**GULF STATES UTILITIES COMPANY**

River Bend Station - Unit 1  
Docket No. 50-458

Enclosed is a revision to the Initial Startup Test Phase of Section 14.2 - Initial Test Program - of the River Bend Station (RBS) Final Safety Analysis Report (FSAR). As Gulf States Utilities Company (GSU) nears completion, fuel loading, and startup of RBS, these changes are necessary to resolve the remaining discrepancies between the FSAR, General Electric's (GE) Startup Test Specification (STS 23A1917) and the as-built plant design. Attachment 1 provides justification and summary explanation of the revisions for clarity while Enclosure 1 contains the marked-up FSAR pages. These revisions will be included in a future FSAR amendment.

Attachment 1

FIGURE 14.2-1  
 START-UP ORGANIZATION  
 RIVER BEND STATION  
 FINAL SAFETY ANALYSIS REPORT

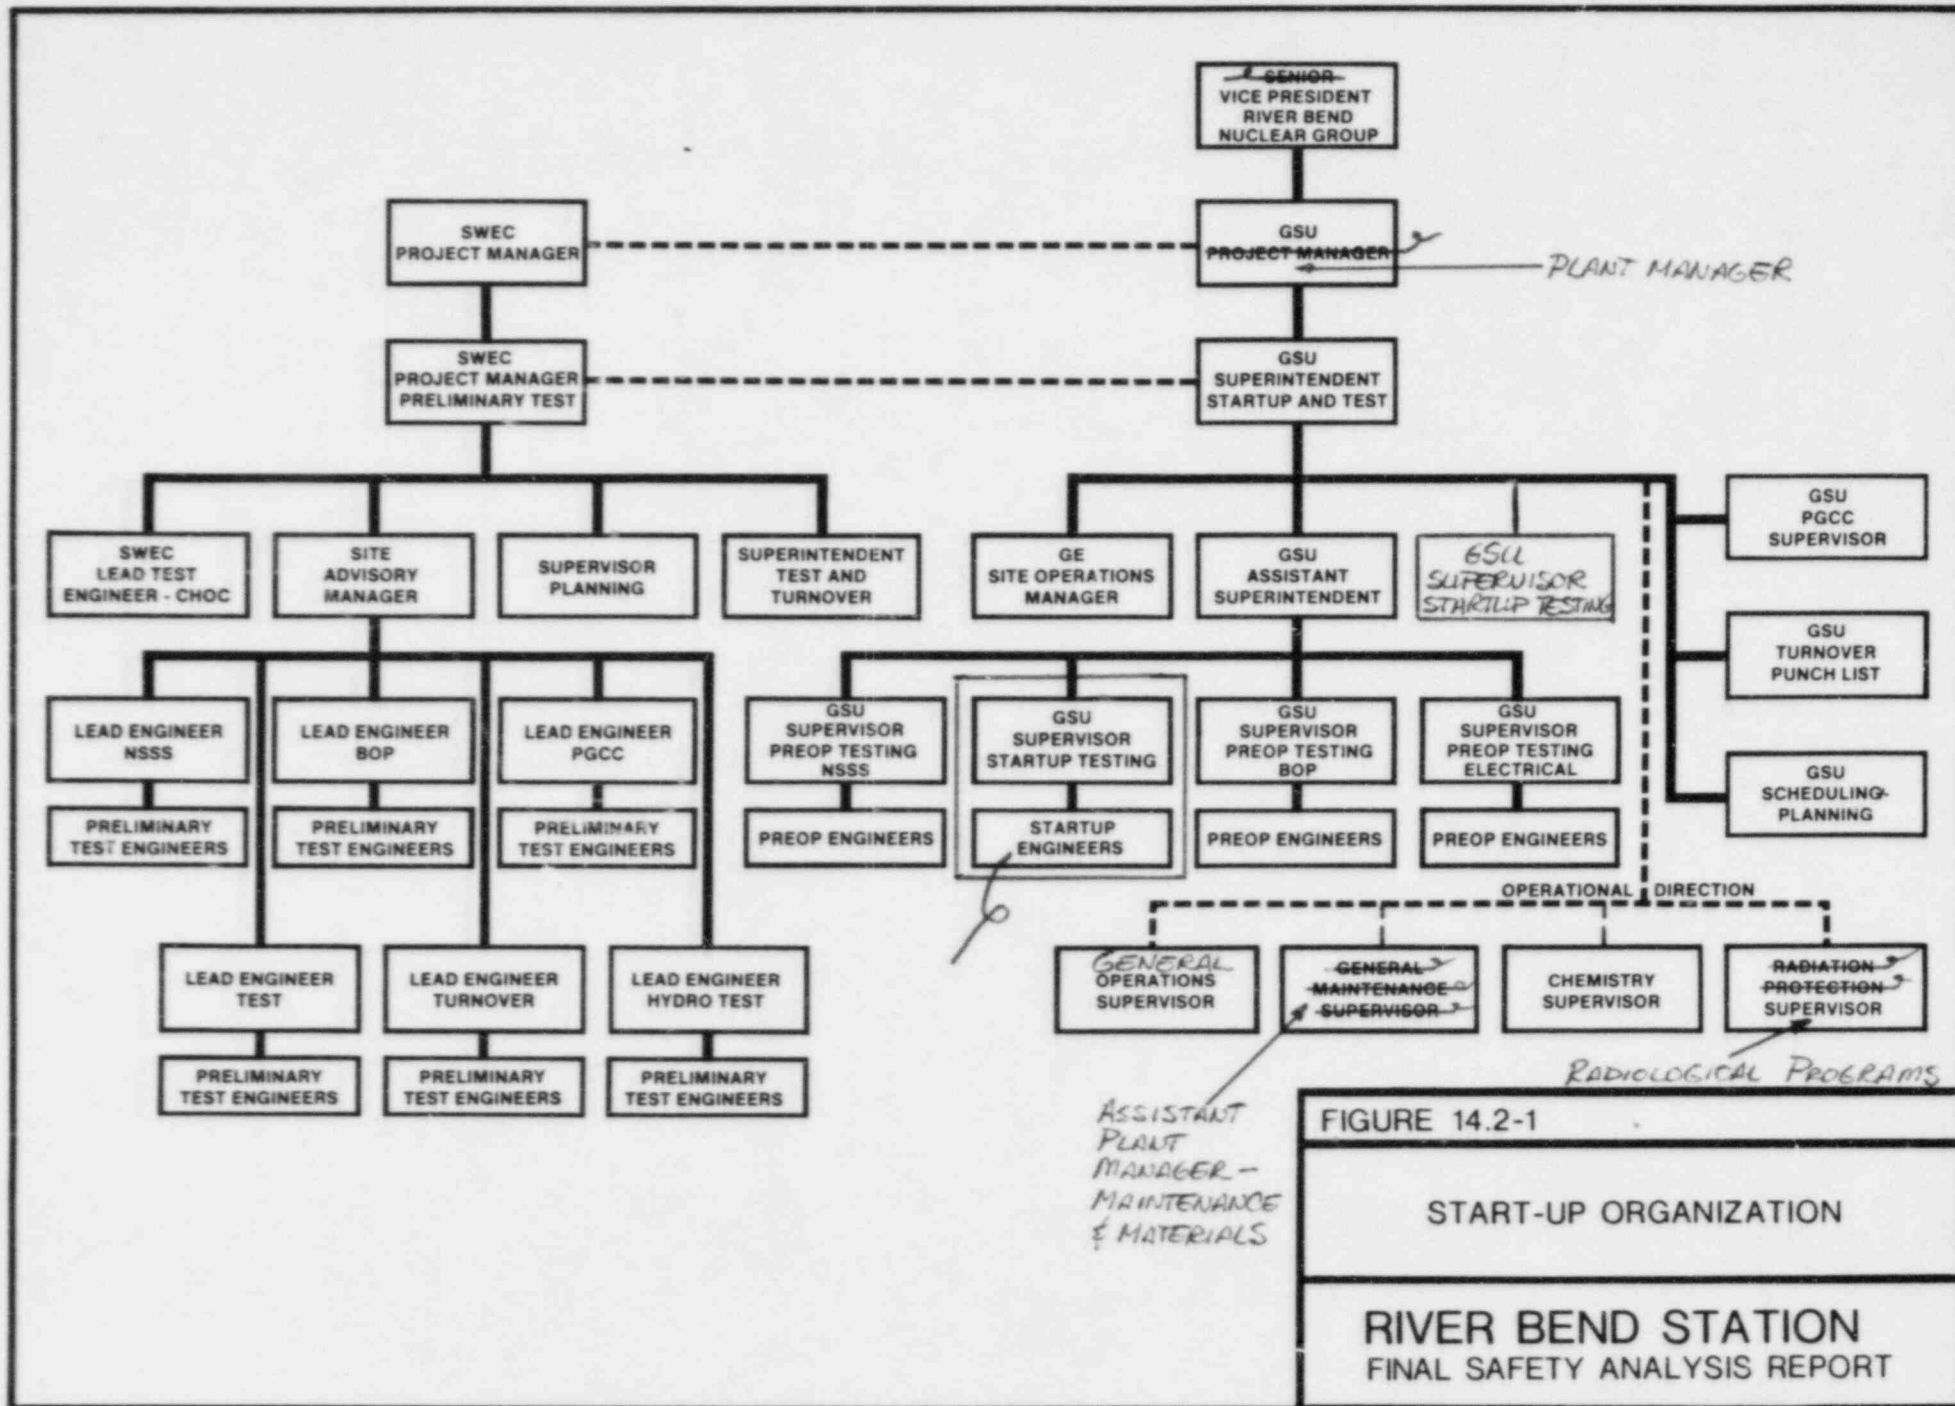
F14.2-1 Revised to reflect current organizational structure  
F14.2-4 Changed to conform to actual conditions  
F14.2-5 Changed to conform to RBS's test plan

FIGURE 14.2-4

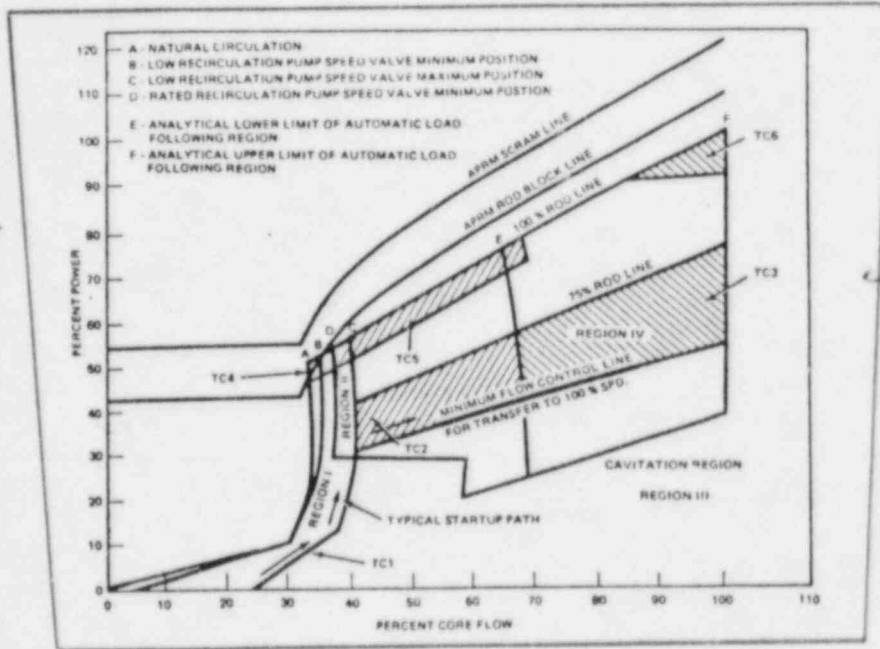
DELETES  
ADD  
REPLACE  
WITH  
REVISED  
FIGURE

FIGURE 14.2-8
RECIRCULATION FLOW STEP CHANGE - ACCEPTANCE CRITERIA
<b>RIVER BEND STATION</b> FINAL SAFETY ANALYSIS REPORT

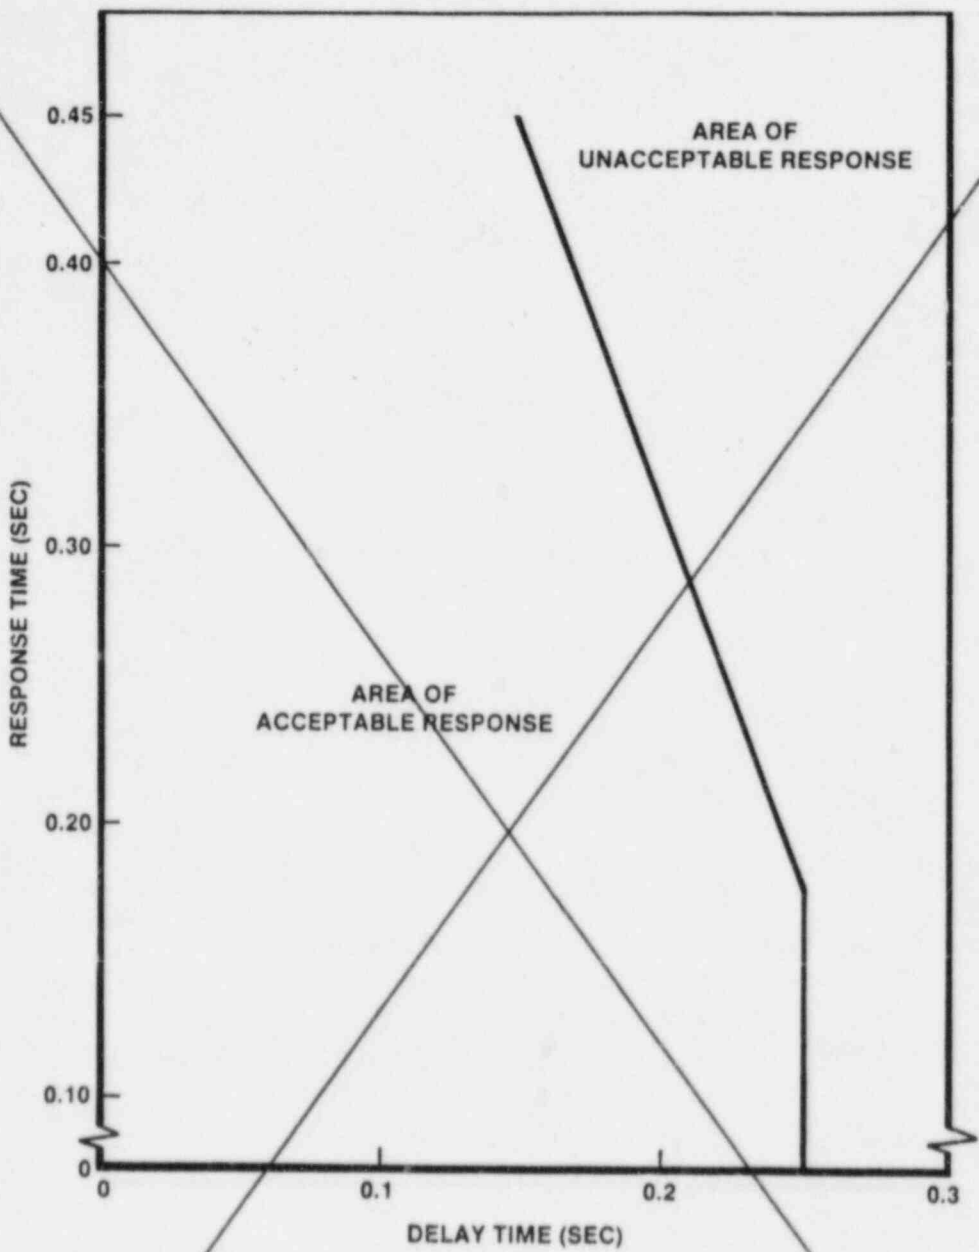
<u>Reference</u>	<u>Justification/Explanation</u>
14-vii 142-186,187	Change the test number to conform to GSU Startup numbering convention
14-viii 14.2-172 F14.2-8	Delete the figure for small recirculation flow step changes. The criteria for 0.2-0.5% step changes is not required by the GSU Startup Test Specification (STS 23A1917) since the input/responses are too small to adequately indicate controller setting.

*DELETE  
THIS  
FIGURE*
